### THM 4L60 (700-R4)

#### PREMATURE 3-4 CLUTCH FAILURE

Figure 1
AUTOMATIC TRANSMISSION SERVICE GROUP

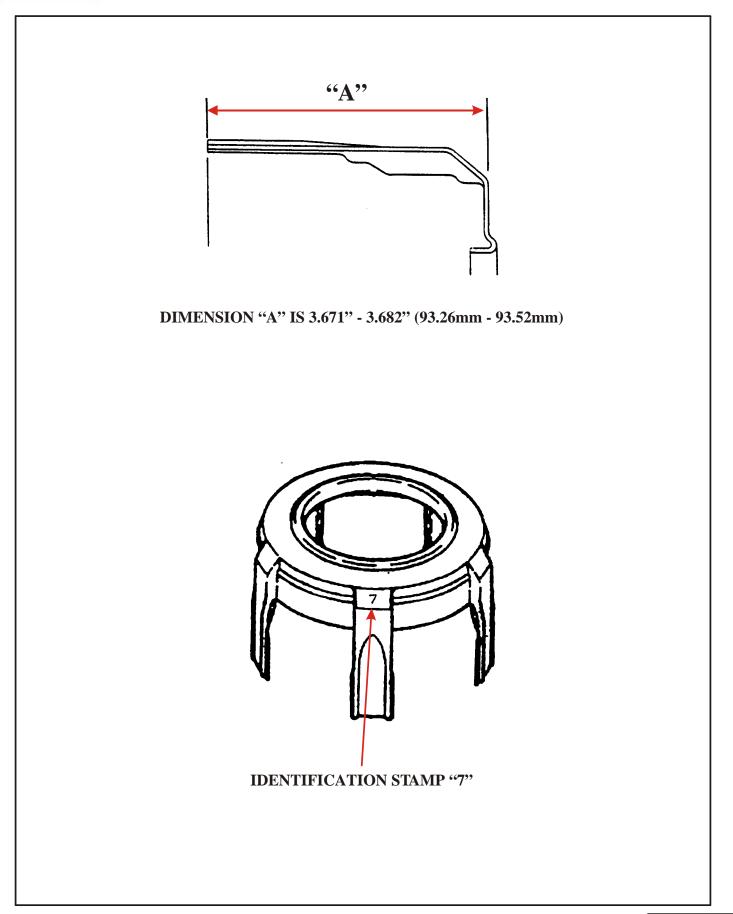
- 1. New design 3-4 Apply Ring with shorter legs (See Figure 1).
- 2. New design one piece 3-4 Apply Plate (See Figure 2).
- 3. New design .106" thick 3-4 Steel Plates, 5 required (See Figure 3).
- 4. New design high energy 3-4 Friction Plates, 6 required (See Figure 3).
- 5. New design 3-4 Selective Backing Plate, as they are thinner (See Figure 4).
- 6. Re-install the 3-4 Load Release Springs in the late design stack-up (See Figure 5).
- 7. *Note:* Ensure that you have .050"-.070" clutch clearance (See Figure 4).

#### **NEW DESIGN APPLY PLATE**

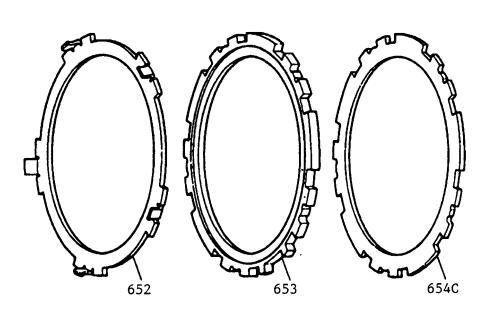
NEW DESIGN APPLY PLATE REPLACES ALL THREE PIECES ABOVE

#### **NEW 3-4 CLUTCH STACK-UP**

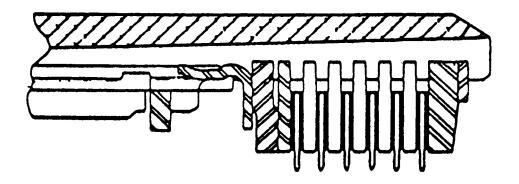
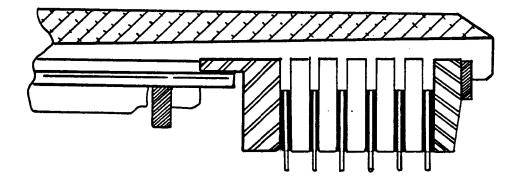
# RE-USE THE 3-4 LOAD RELEASE SPRINGS IN THE NEW DESIGN CLUTCH PACK ONLY

Re-install the 3-4 load release springs when you are using the .106" thick steel plates, 2050 high energy lined plates, new design 3-4 apply ring, new design one piece apply plate, and new design backing plate.
